Re: Docket No. 516 – The United Illuminating Company Application for a Certificate of Environmental Compatibility and Public Need for the Fairfield to Congress Railroad Transmission Line 115-kV Rebuild Project

Enclosed for filing with the Connecticut Siting Council (“Council”) are The United Illuminating Company’s (“UI”) Late Filed Exhibits as requested by the Council during the October 17, 2023 hearing.

Late Filed Exhibit 3-1

1130 Line Rebuild Alternative Design

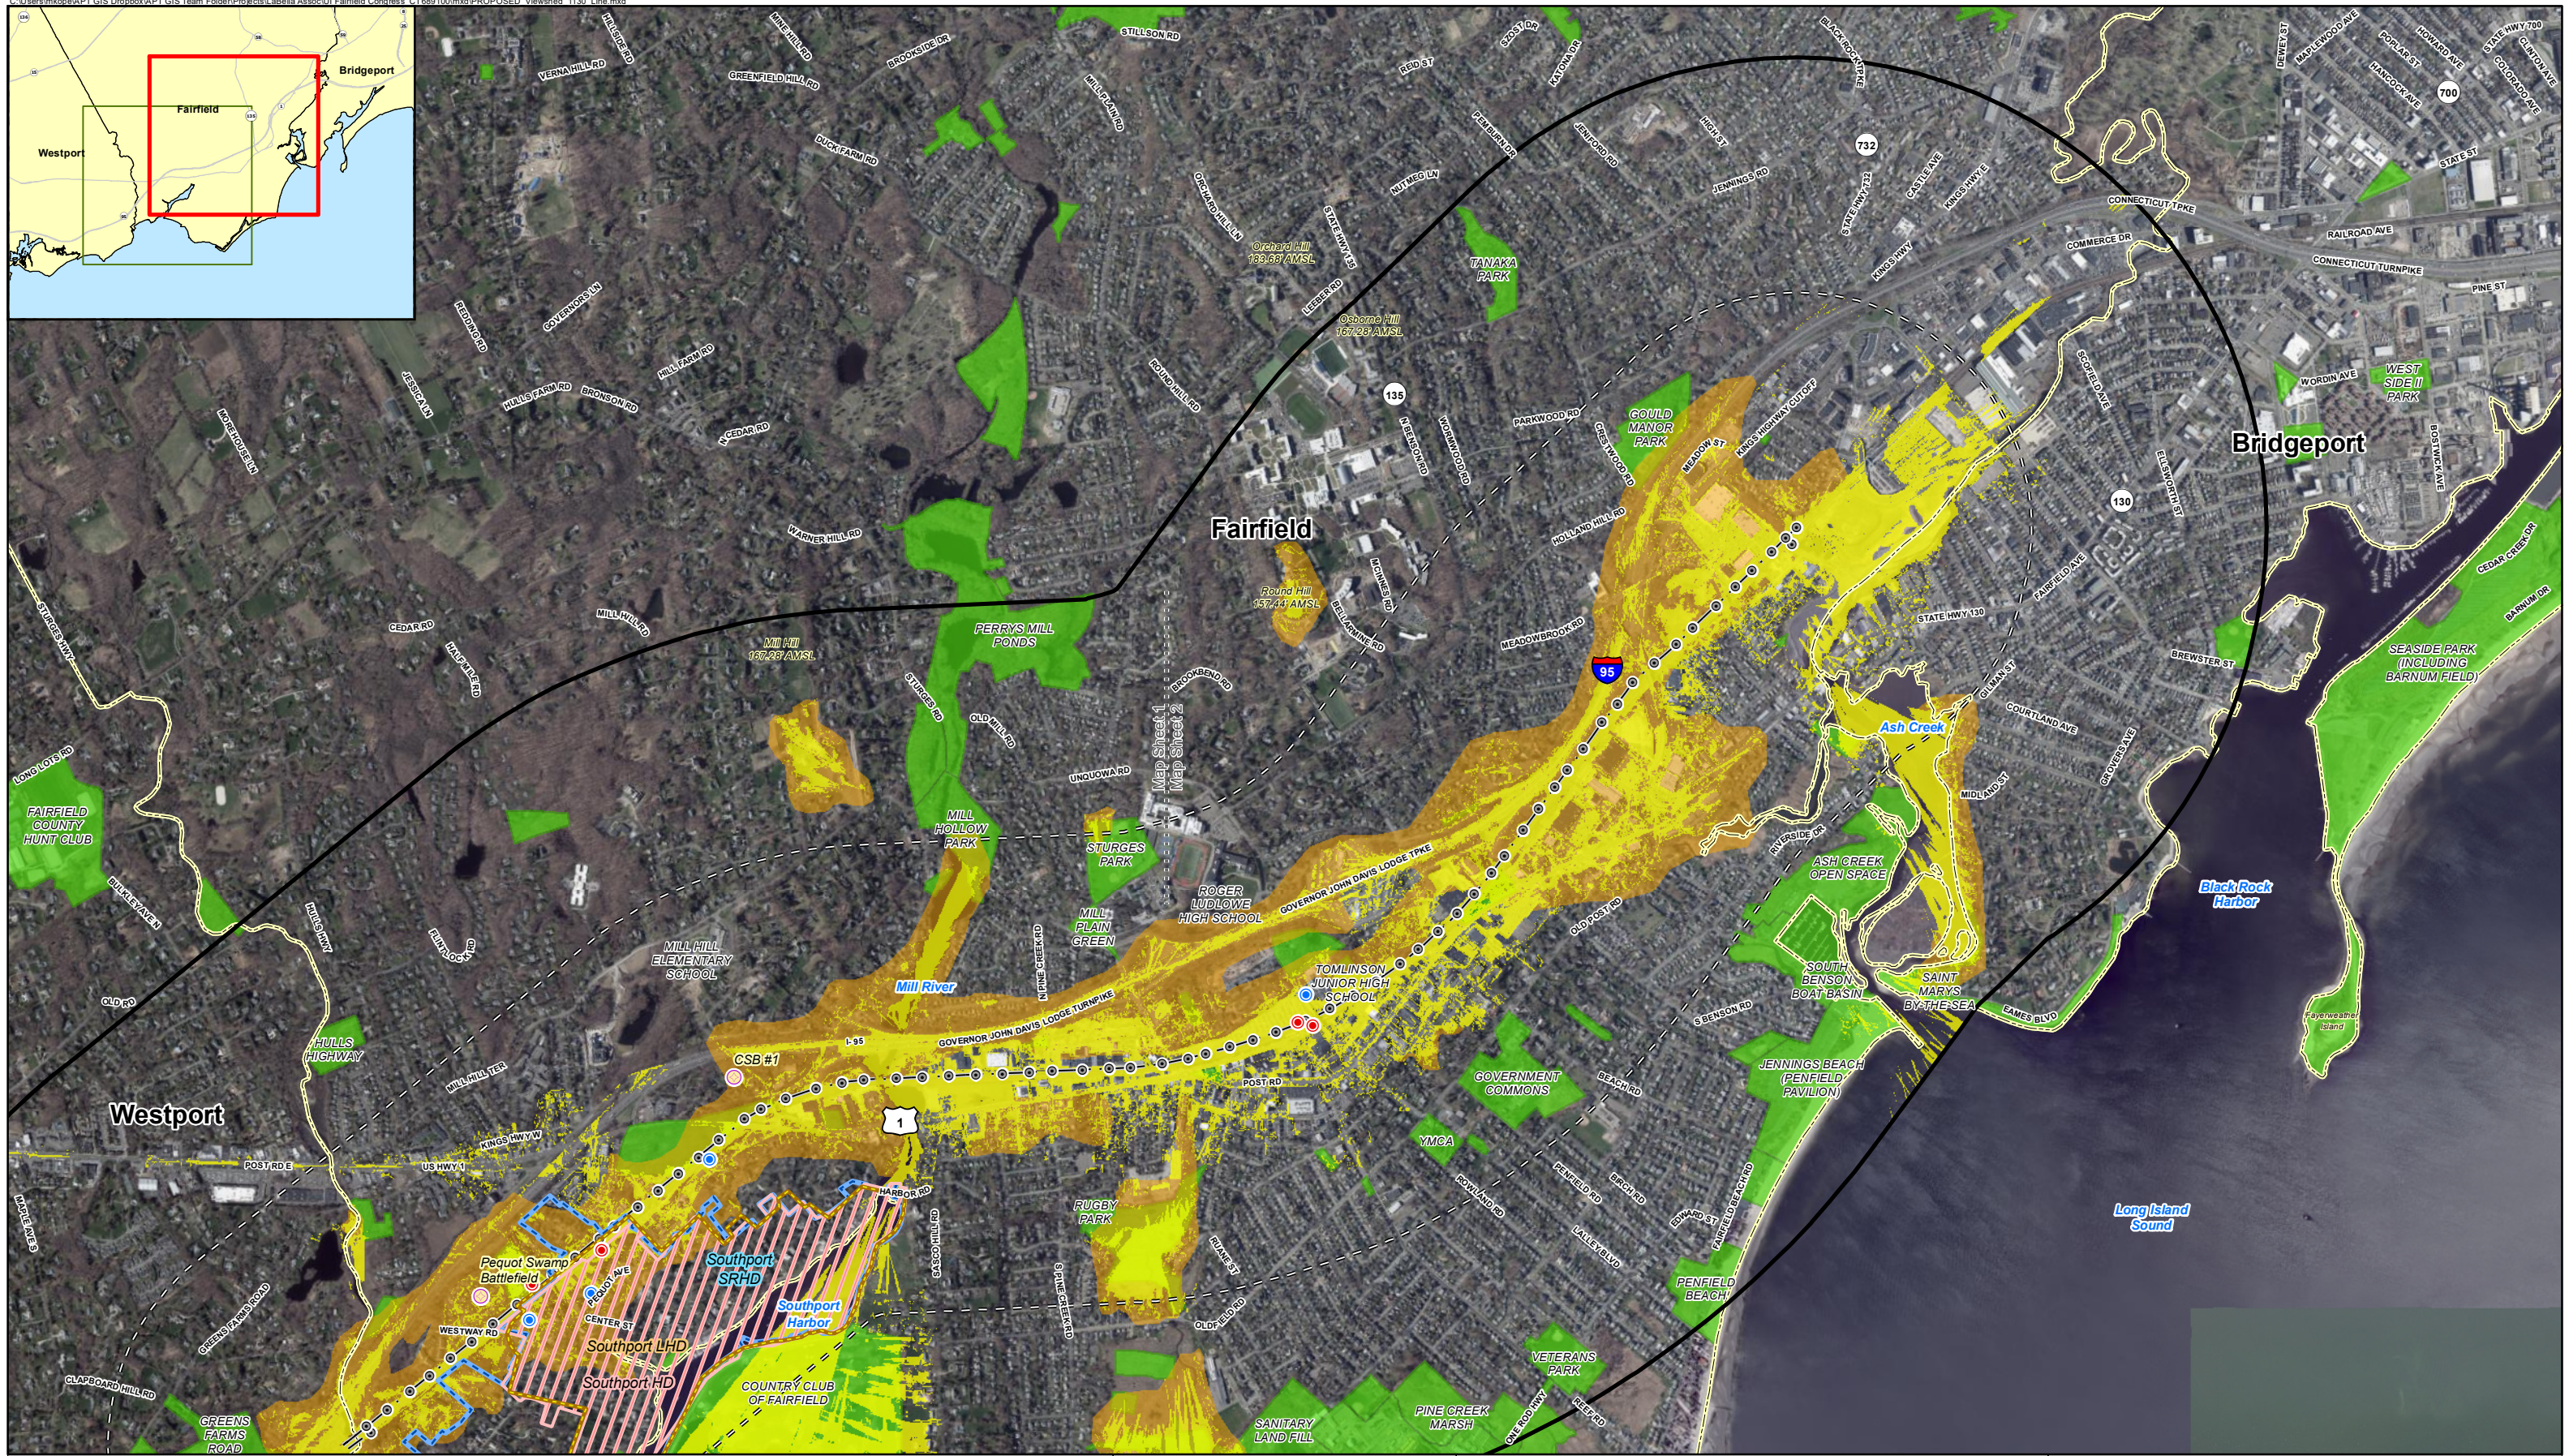
Q-LFE 3-5: Viewshed analysis for the double-circuit monopole configuration alternative from Late File 2-5(a);

A-LFE 3-5: Please see Attachment LFE 3-5-1.

Figure 1. Configurations of the Project-related transmission lines and CT DOT catenary structure (view facing northeast) for XS-2.

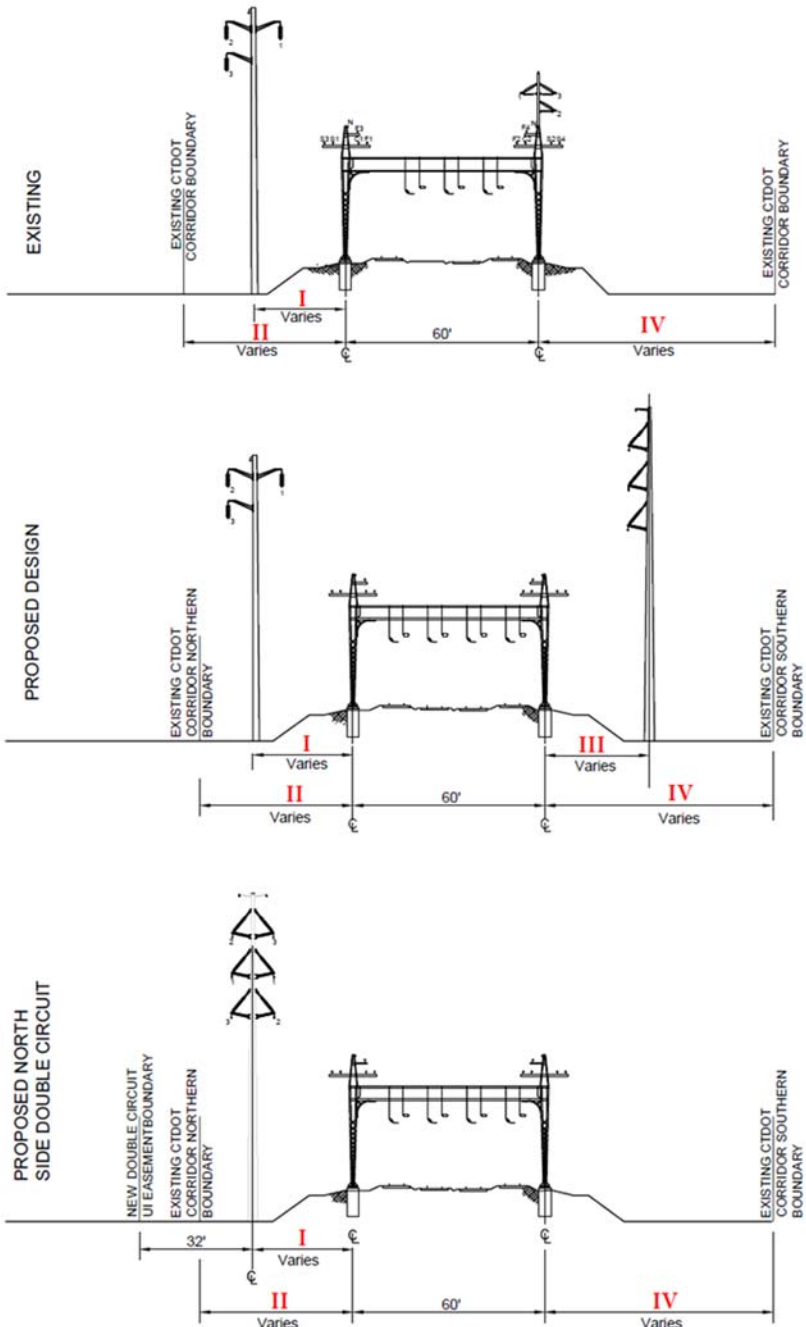
Q-LFE 3-11: Any changes to EMF on the north side of MNRR for the configurations identified in Late File request Nos. 2 through 6 and 10 above;

During the October 17, 2023, evidentiary hearing session regarding the Project, the CSC requested that UI submit an evaluation of changes to EMF if the Project were re-designed to use a double-circuit monopole configuration, to be located on the north side of the railroad tracks between existing Catenary Structure 648S and the point at which UI's lines extend south from the railroad tracks to Ash Creek Substation (i.e., modeling cross sections XS-1 through XS-7 in the Original Exponent EMF Report).

The requested redesign of the Project would involve replacing the existing single-circuit monopole structures currently supporting Line 1130 and rebuilding both Line 1130 and Line 1430 on double-circuit monopole structures on the north side of the CT DOT corridor.²

Along different portions of the route, the existing Line 1130 monopoles are offset by varying distances (approximately 0 to 9 ft) from the existing catenary structures based on the CT DOT corridor's width and clearance requirements specified by the CT DOT and the MNR at the time that the 1130 Line was constructed approximately 32 years ago. The new double-circuit structures are assumed to be rebuilt in line with the existing structures.³ However, under the double-circuit configuration, since there would be transmission line conductors on both sides of each monopole structure, UI would have to procure an additional easement up to 32 ft from the center line of the new double-circuit monopole structure, where needed.⁴

the design of existing structures, and the widths of existing and proposed UI easements, as described in greater detail in the Original Exponent EMF Report. Several dimensions vary through the modeled route, as illustrated in Figure 1:
